PR/0417/23

Record of Executive Business and Chief Executive's Order

Reg. Reference:SDZ22A/0014Application Date:26-Oct-2022Submission Type:AdditionalRegistration Date:23-Mar-2023

Applicant Name: Quintain Developments Ireland Limited

Table 2.1: Net Development Area and residential yield and densities at Aderrig

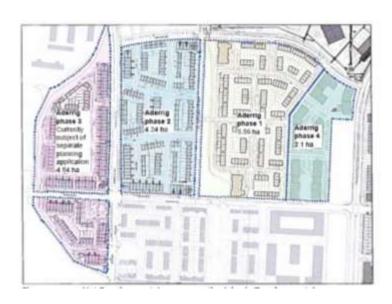
The Applicant's proposal regarding density may be acceptable. In order to determine this, the applicant is requested to provide the following information:

b. The applicant is also requested to provide a plan indicating Net development area for the current proposal and for the wider Aderrig area. This should be annotated with areas in sq.m / ha, as relevant.

a. the density of Phase 4 will exceed the +/-20% density range facilitated by the Planning Scheme

Phases 1 and 4 are located on the same parcel of Net Development Area per the Planning Scheme (Figure 1.2) and could be considered an individual development site" with their combined density of 74.7 uph falling within the +/- 20% range of 41.6—84 uph allowed by the Planning Scheme.

Phase - Parent Reg. Ref.	Net Dev. Area (Ha)	Yield	Density
1-SDZ20A/0017	5.56	235	42.3
2 - SDZ21A/0014	4.24	227	53.5
3 - This Planning Application (RFI-Stage)	4.84	207	42.8
4 - Current Proposal (PPC-Stage)	2.1	337	160.5
Actual Net Dev. Area	16.74	1,006	60.1
Planning Scheme Net Dev. Area	17.8	1,006	56.5
Phases 1 & 4 Combined	7.66	572	74.7
